IRRIGATION SYSTEM STANDARD DETAIL

GREATER WENATCHEE IRRIGATION DISTRICT

REVISIONS REVISED: 12/07/2021 DWG NO.REV 1

IRRIGATION SYSTEM STANDARD DETAIL **REVISIONS (CONT'D)**

IRRIGATION TRENCH DETAIL

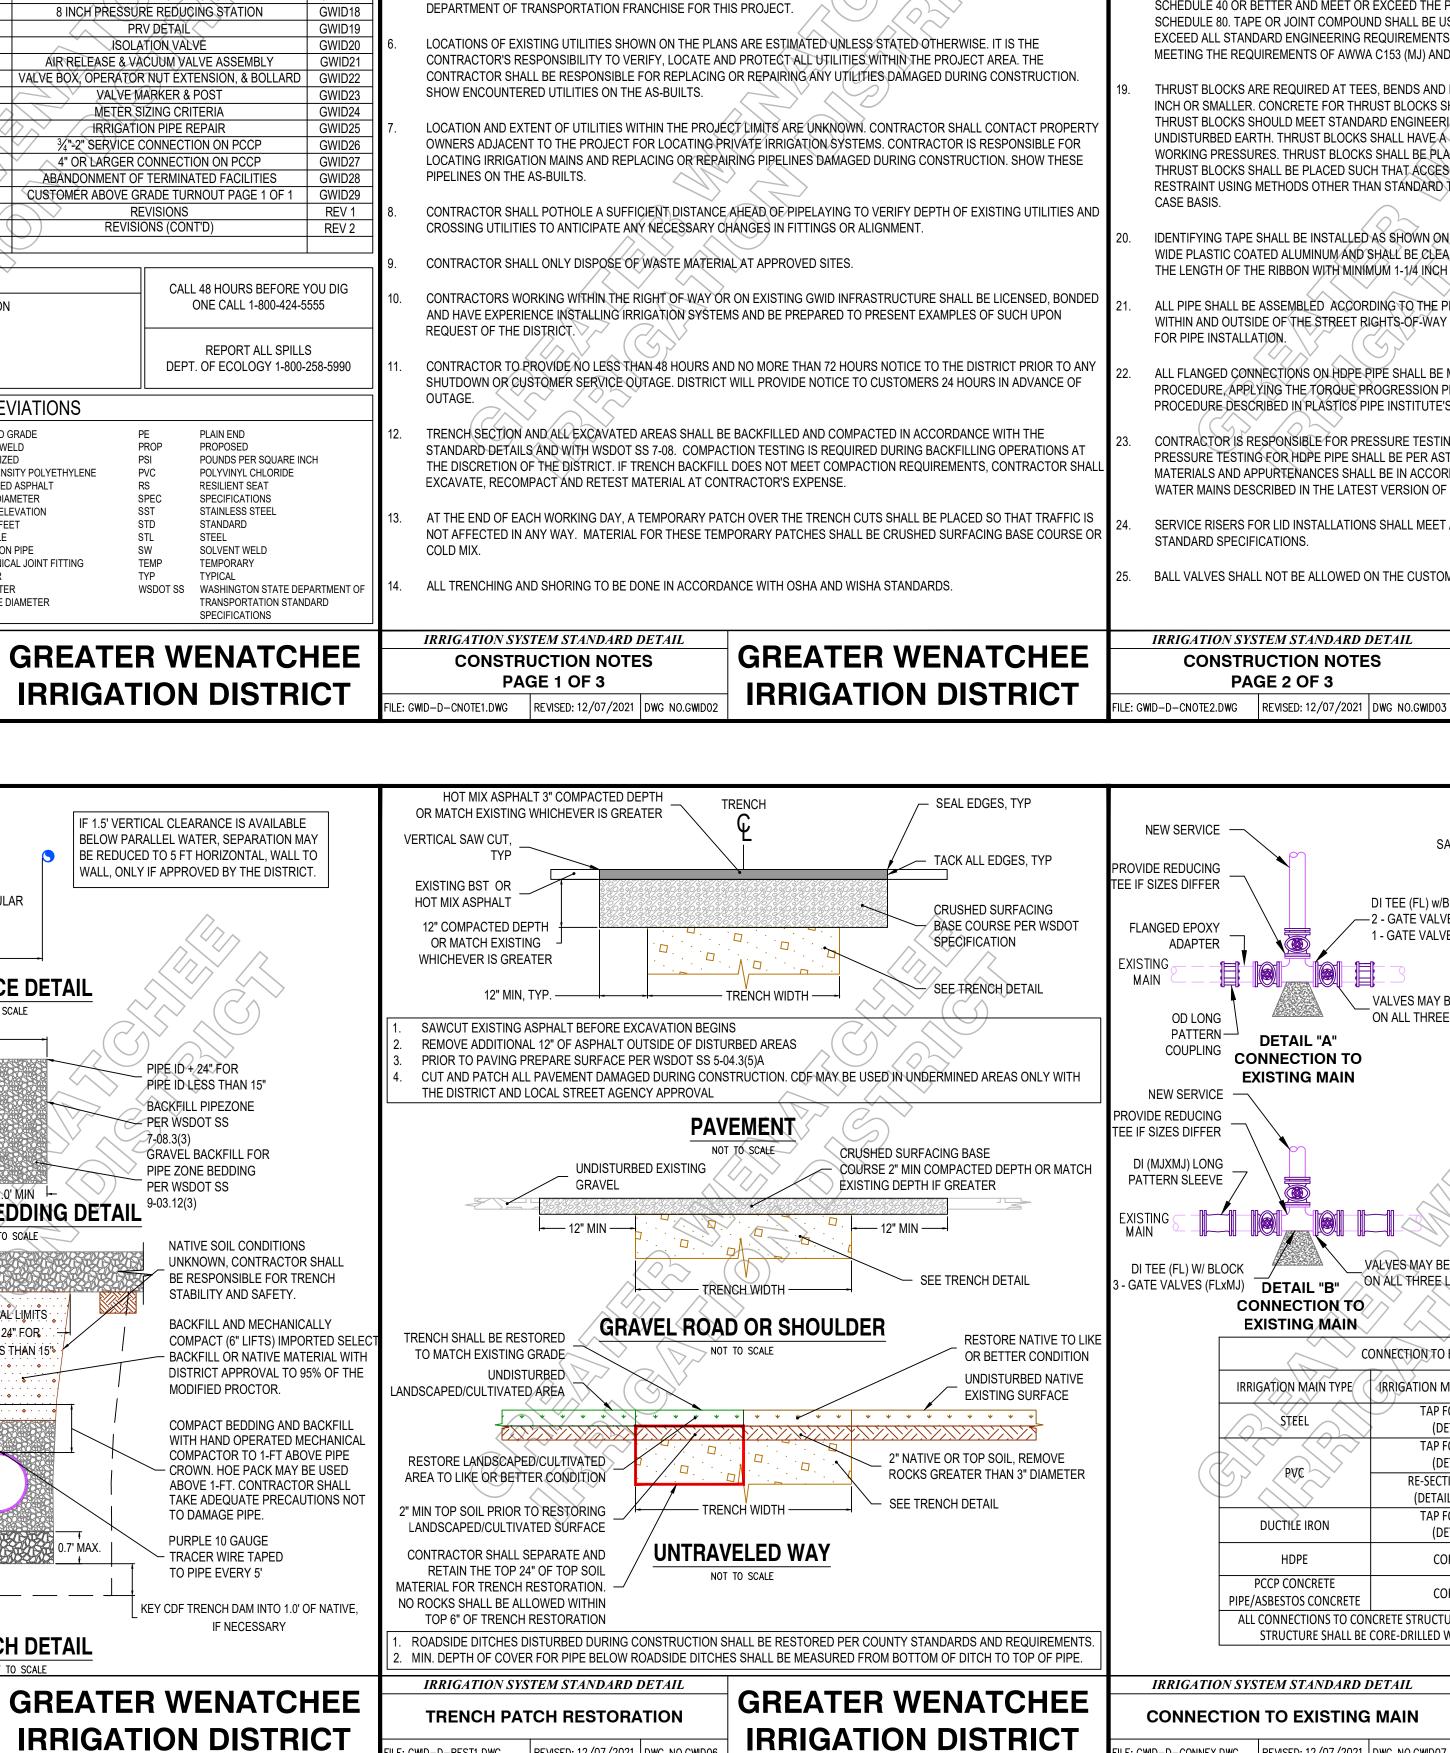
GWID05 - ADDED NOTE ABOUT COMPACTION WITHIN 1.0 FT ABOVE THE PIPE. (JRS)

IRRIGATION SYSTEM STANDARD DETAIL **ABANDONMENT OF TERMINATED FACILITIES** REVISED: 12/07/2021 DWG NO.GWID28

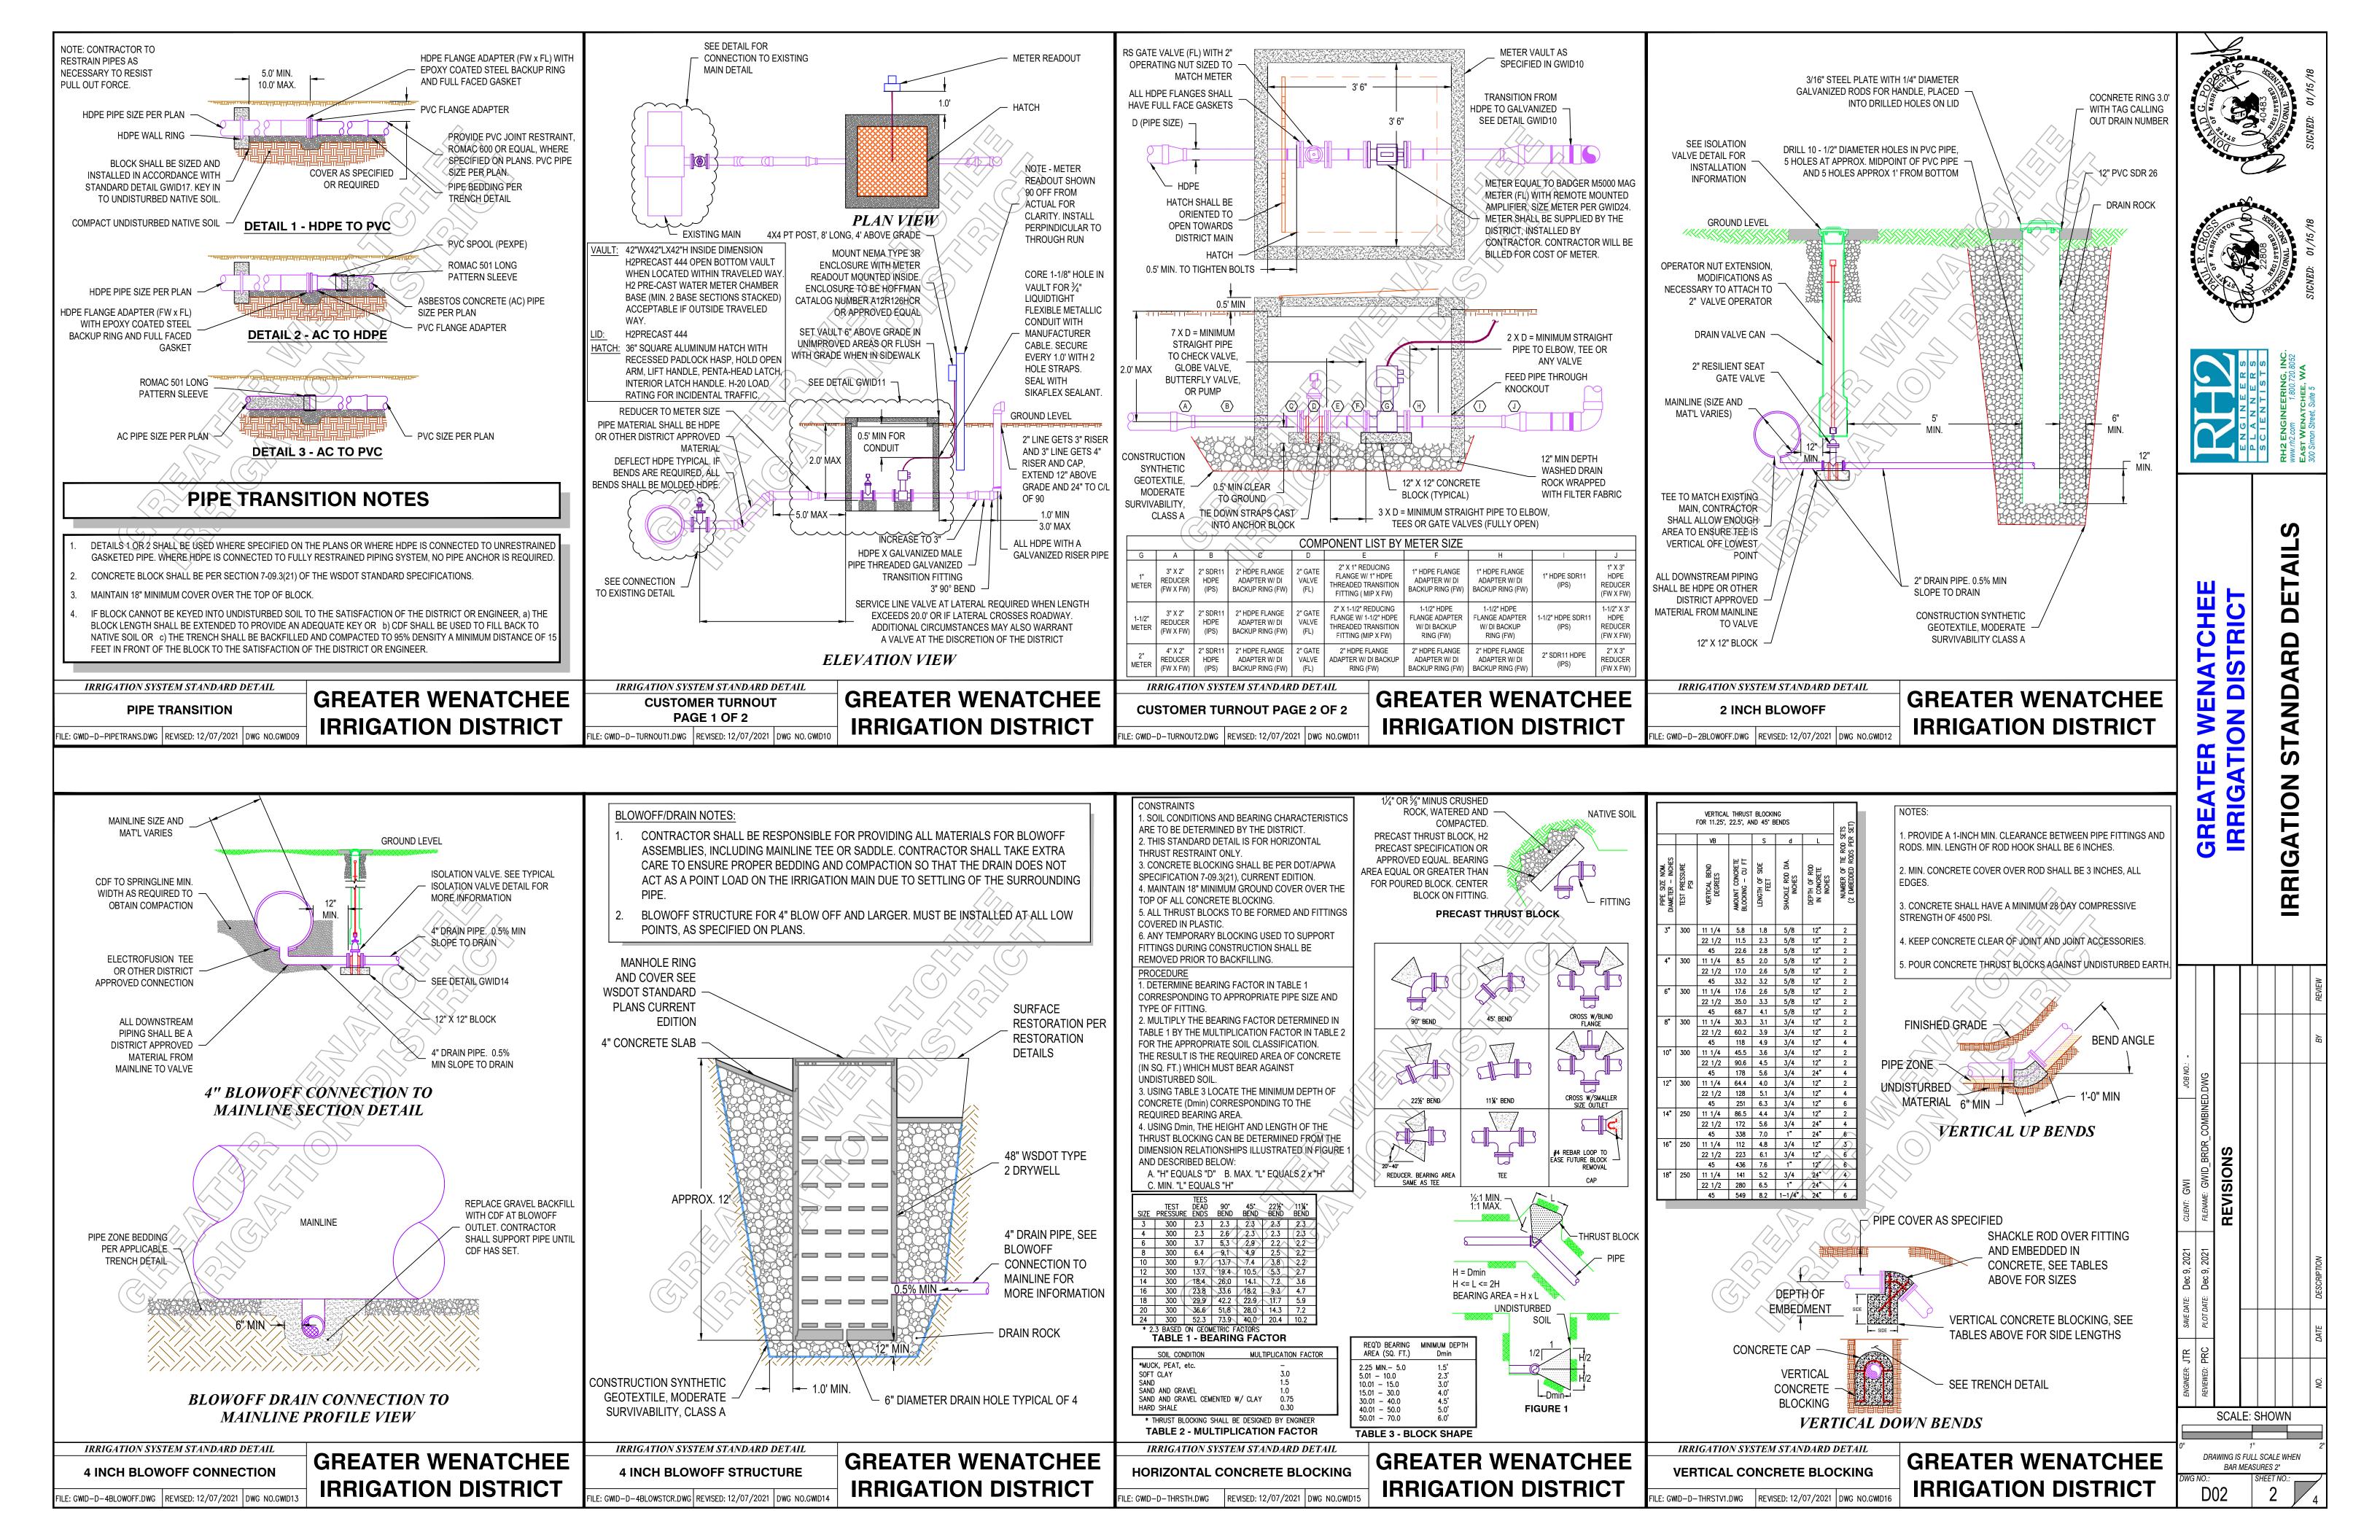
GWID28 - ADDED "ABANDONMENT OF TERMINATED FACILITIES" DETAIL. (JKK)

IRRIGATION SYSTEM STANDARD DETAIL **GREATER WENATCHEE CUSTOMER ABOVE GRADE TURNOUT PAGE 1 OF 1** FILE: GWID-D-AGTURNOUT.DWG REVISED: 12/07/2021 DWG NO.GWID29

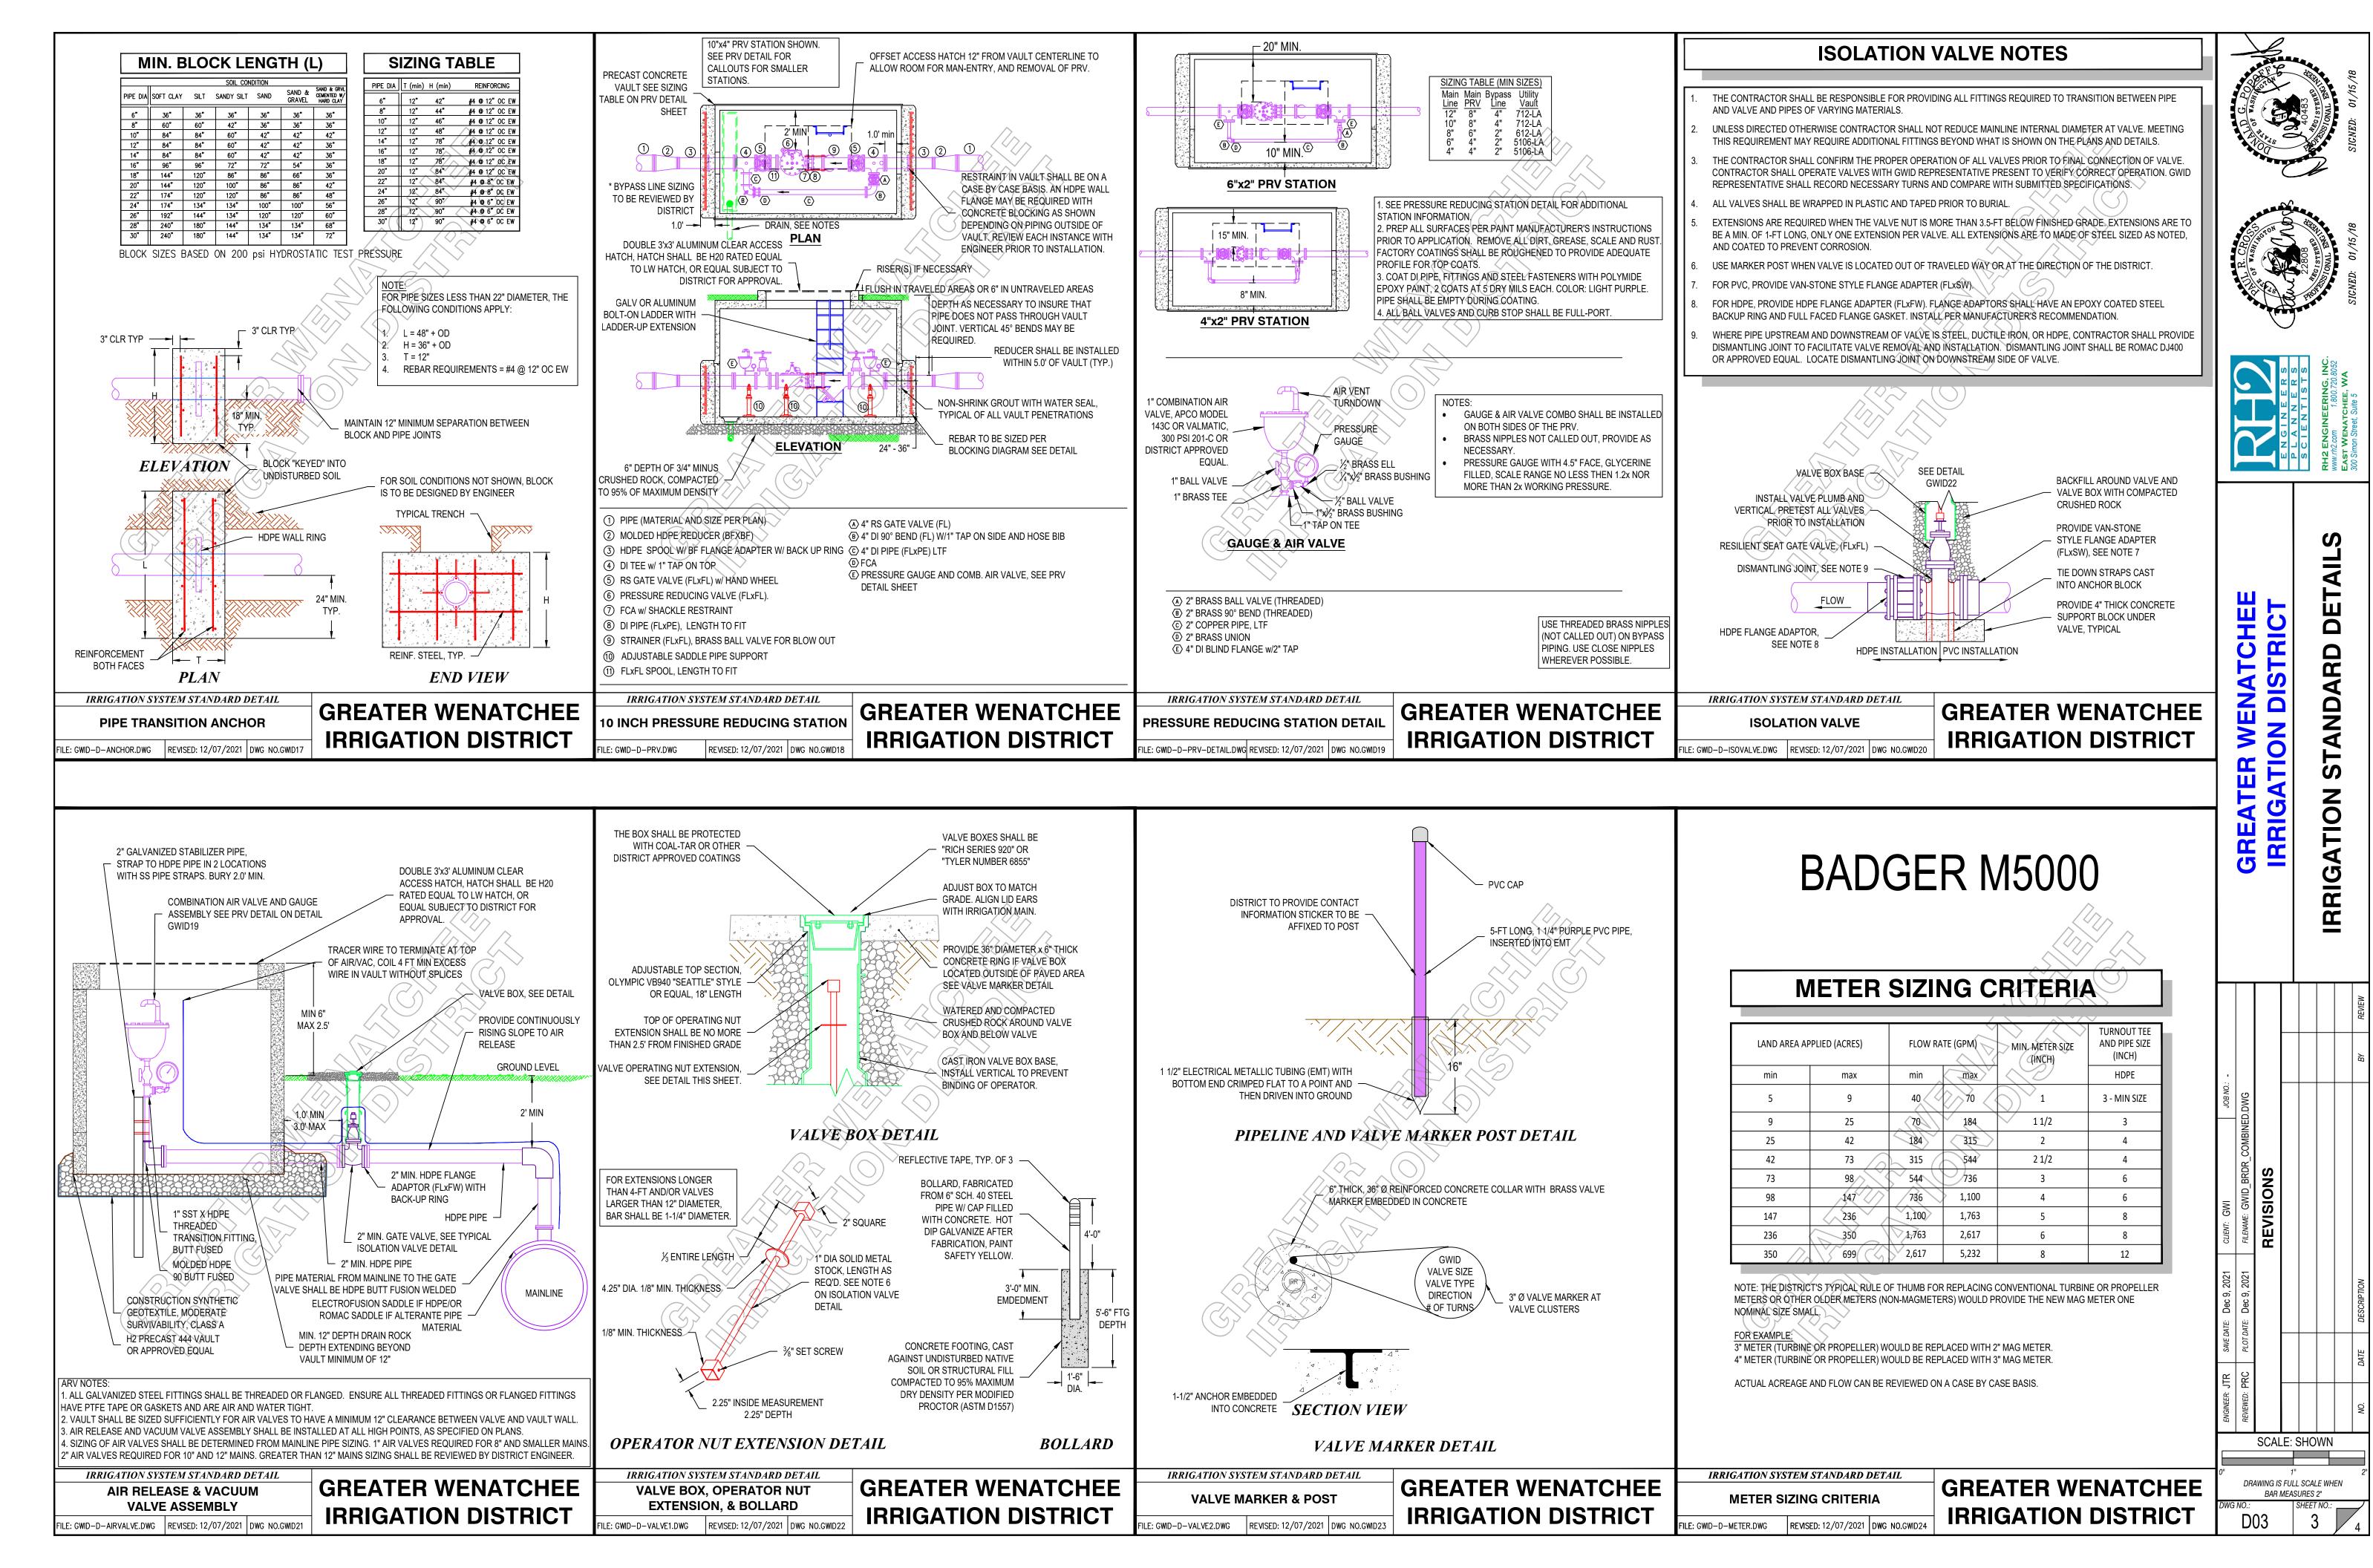
GWID29 - ADDED "CUSTOMER ABOVE GRADE TURNOUT" DETAIL. (JRS)
